SPI 351
Page 1 of 7
Rev. "D" 11-19-65

Subject: Release of Greased Input Drive Configuration

Subject: Change In Stator Design

ALLISON TORQMATIC CONVERTER SERIES 200-300 PARTS CATALOG

STATOR CAM P/N 3719260 SHOWING
POSITION OF ROLLER AND SPRING

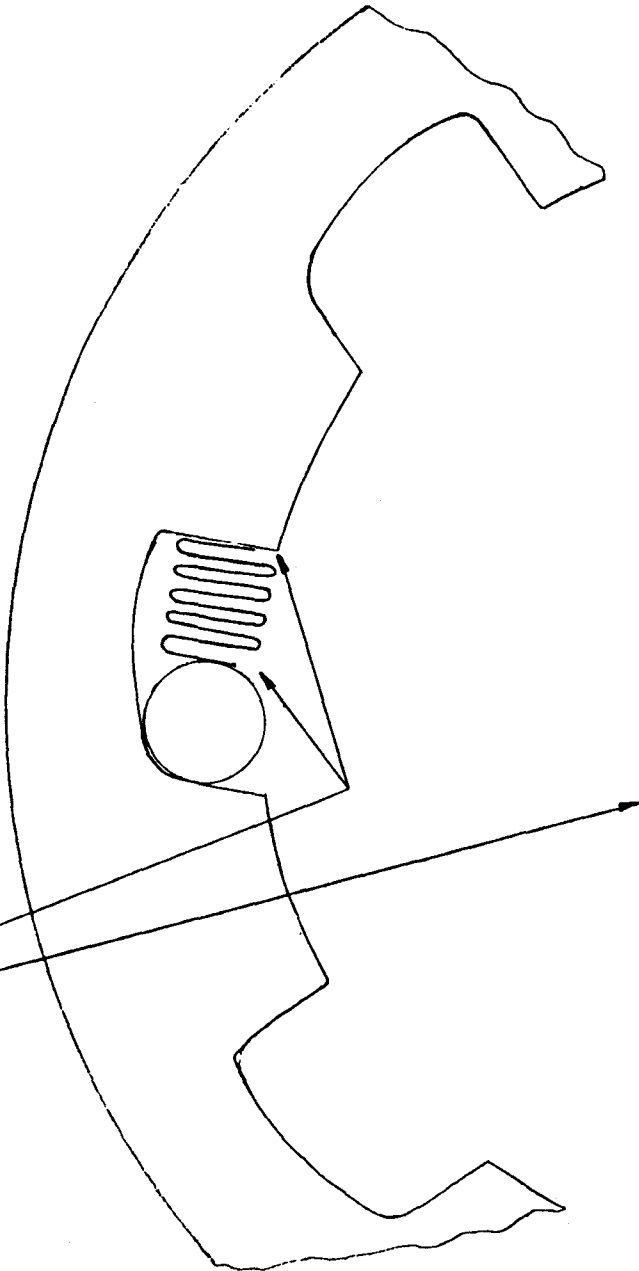
OPEN ENDS OF SPRING
TOWARD GROUND SLEEVE

CONVERTER WITH FRONT DISCONNECT CLUTCH

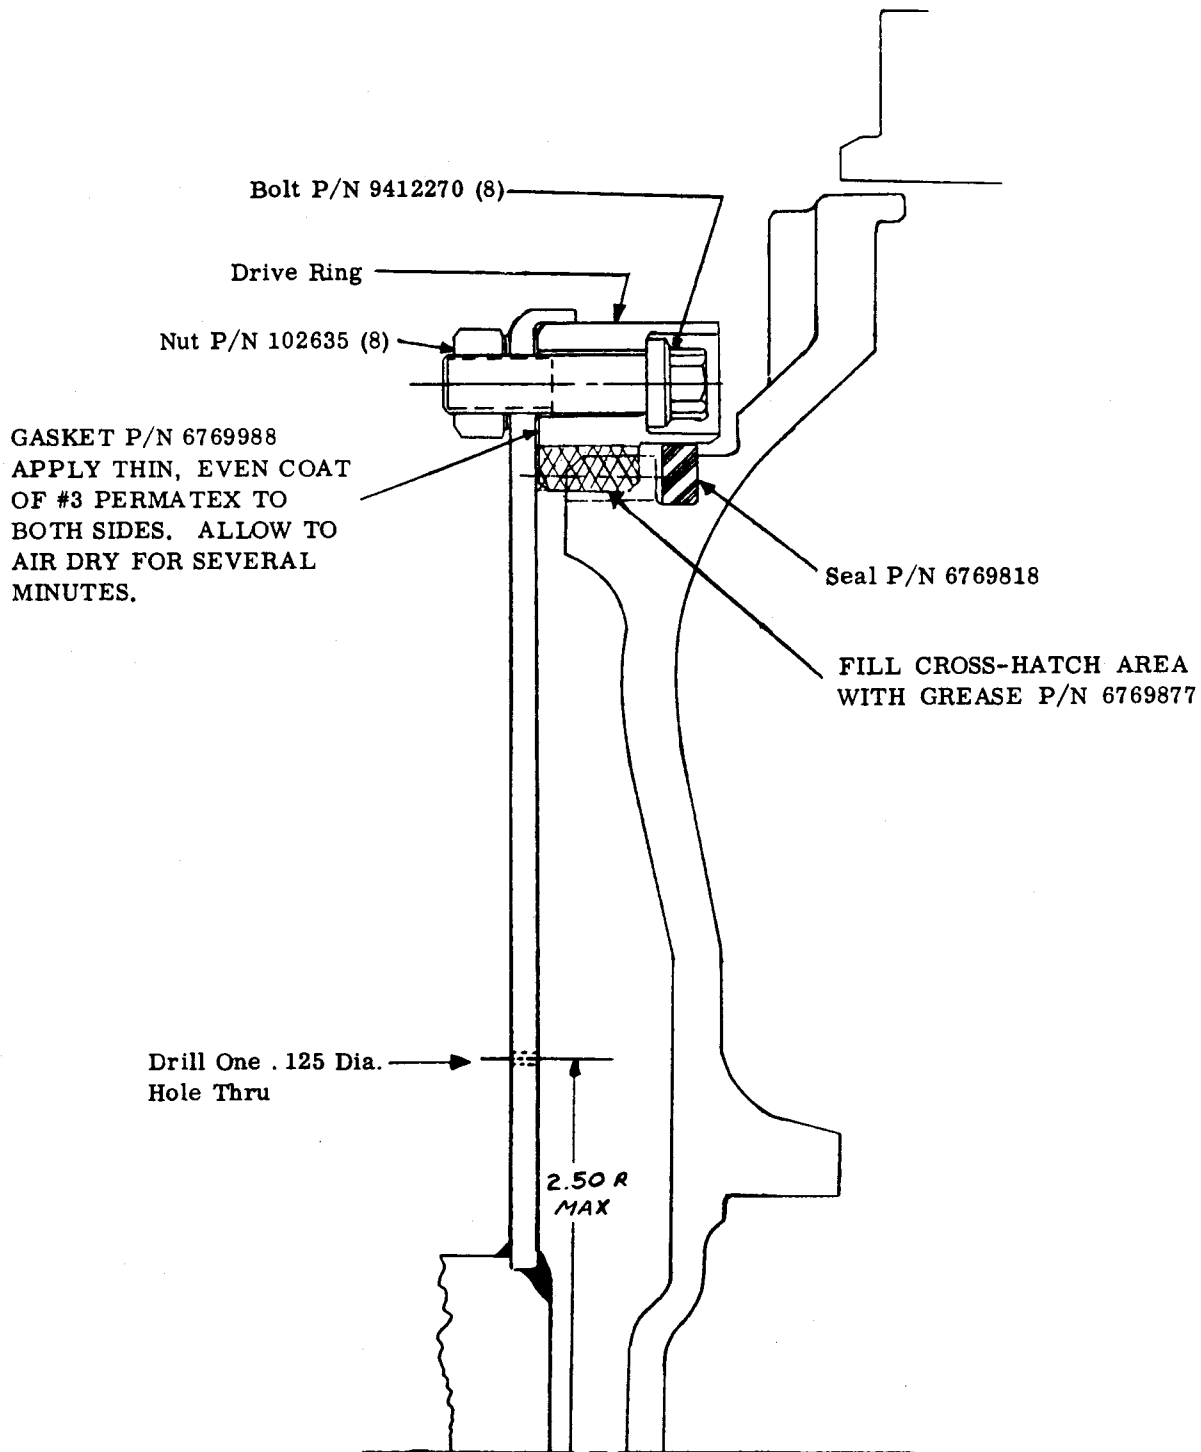
4. Apply a thin, even coat of #3 Permatex to the face of the ring gear and the mating surface on the flywheel. (In front disconnect models of TC-300 converters, apply the Permatex to both sides of gasket P/N 6769988.) Allow the Permatex to air dry for several minutes.

5. Bolt the ring gear P/N 6769876 to the flywheel (Standard Models) or to the clutch drive plate (Front Disconnect Models), using eight bolts P/N 9412270. (Front Disconnect Models will also require eight P/N 102635 nuts and one P/N 6769988 gasket.) Tighten the bolts to 36-43 lb.-ft. torque.

6. Apply a thin film of grease to the seal P/N 6769818 and install the seal in the groove behind the gear teeth in the converter drive cover.
7. Distribute enough grease P/N 6769877 around the inside of the drive ring to fill the spaces between the gear teeth and the cavity between the flywheel and the drive ring as shown by the cross-hatch area in attached sketches. The amount of grease used should be held to a minimum - approximately 1 1/2 ounces. Use grease only in the cross-hatched area shown.

STANDARD CONVERTERS & CRT-3000 SERIES TRANSMISSIONS

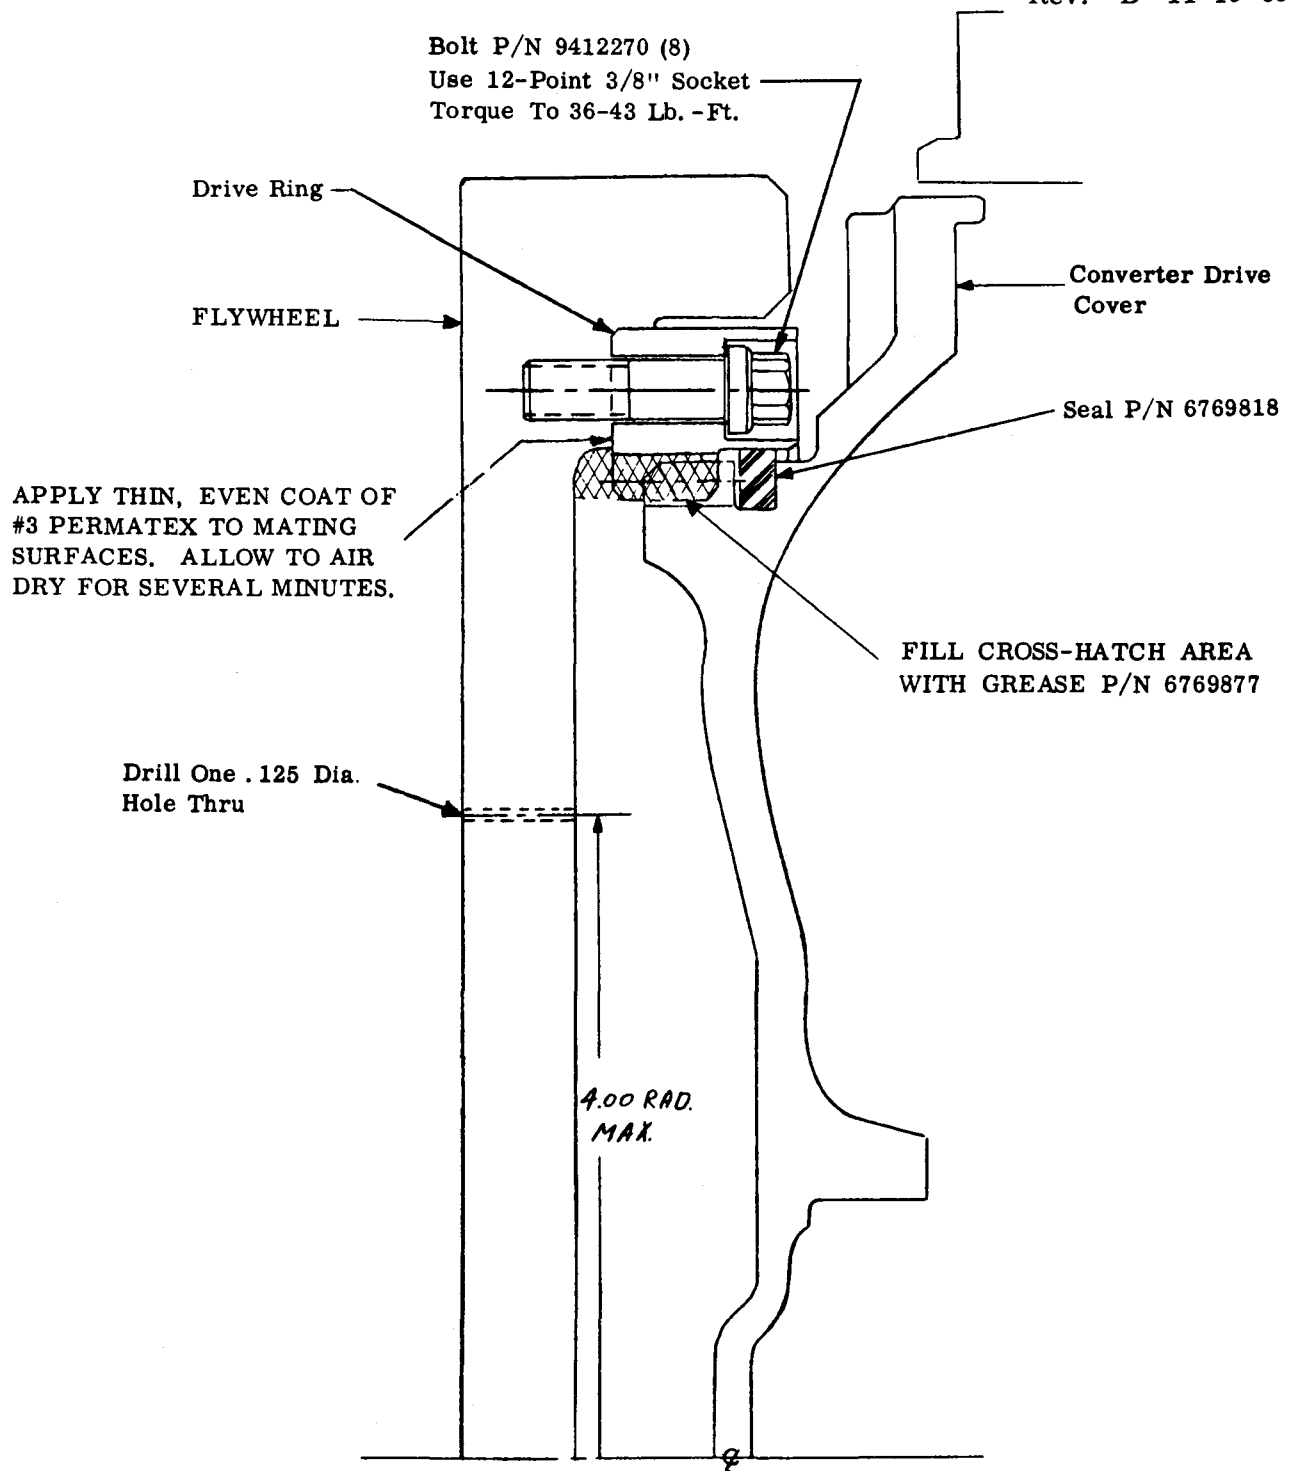
1. If the converter drive cover on the transmission or converter is a rollpin type cover, or if it is a badly worn gear type cover, it must be replaced by a new gear type cover P/N 6772408. (TC-376 converters, Assy. No. 6759643, require cover assembly P/N 6769849).
2. Remove the ring gear from the engine flywheel.
3. Drill one 1/8" vent hole in the engine flywheel or in the disconnect clutch drive plate. This should be located inside a 4" radius from the center of the flywheel, or, in converters with the front disconnect option, inside a radius of 2 1/2" from the center of the drive plate. Avoid drilling into the area which mates with the crankshaft flange.

Instruction Sheet No. 38
(For Kit P/N 6774685)

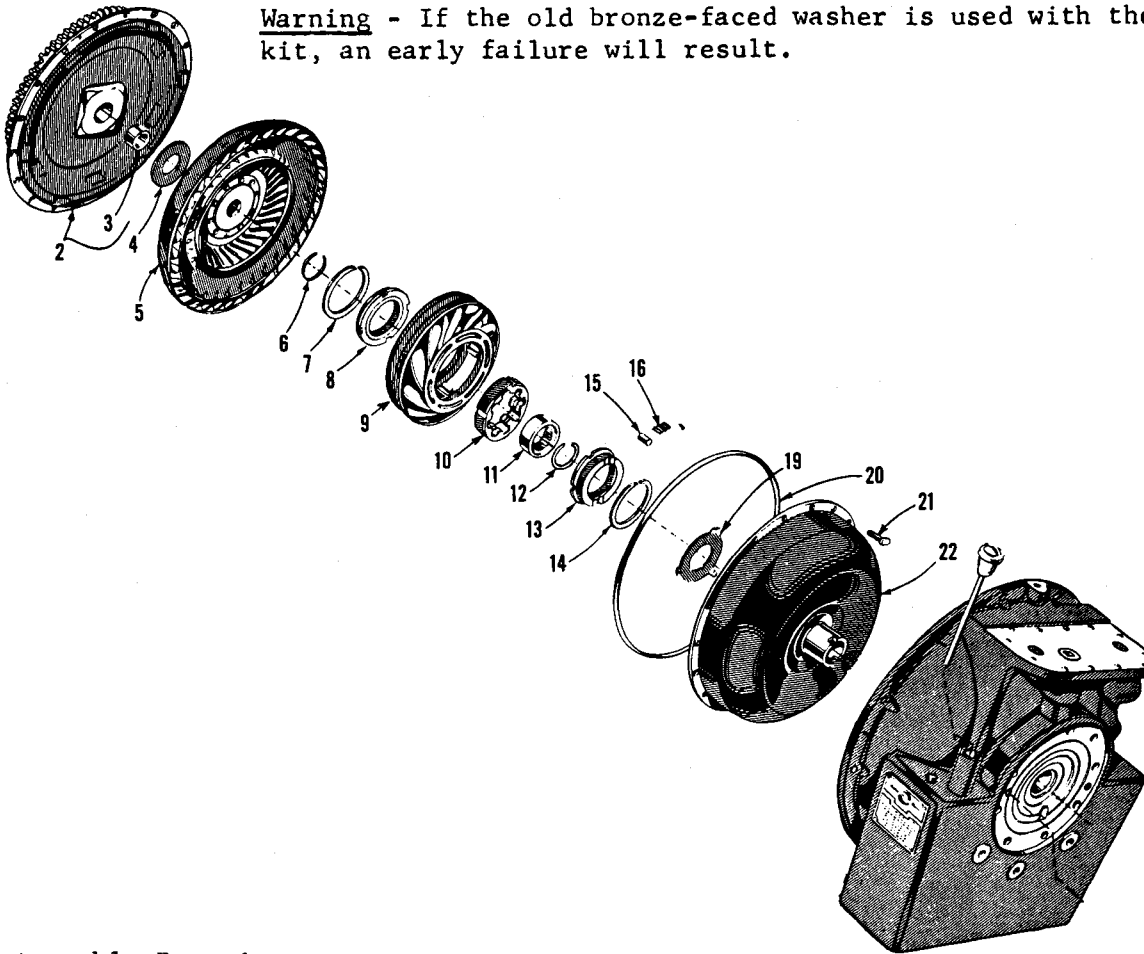
PLEASE NOTE: If the serial number of the converter you are repairing is below S/N 3182, be sure to remove and discard the old converter pump thrust washer. It is a steel washer which has three tabs and a bronze facing. The new thrust washer, P/N 3702744, has the three tabs but does not have the bronze facing.

Warning - If the old bronze-faced washer is used with the parts in this kit, an early failure will result.

1. Assemble the converter to the point where the converter pump (22) has been installed.
2. Install the new thrust washer (19) and the snapring (12).
3. Note the word "Front" cast on one side of the stator (9). Turn the stator over and install the thrust washer (13) and the snapring (14).

4. Install the cam (10) into the stator, from the front side. Be sure the deep end of the cam pockets are in a counterclockwise direction.
5. Install the rollers (15) and springs (16) into the cam pockets, positioning the springs so that the open ends will be next to the race (11).

6. Insert the race into the stator, then install the stator and race onto the stator support (groundsleeve). Work carefully to prevent the rollers and springs from dropping out of the stator.

7. Install the snapring (6) into the groove in the stator support.
8. Install the thrust washer (3) and the snapring (9) into the stator.
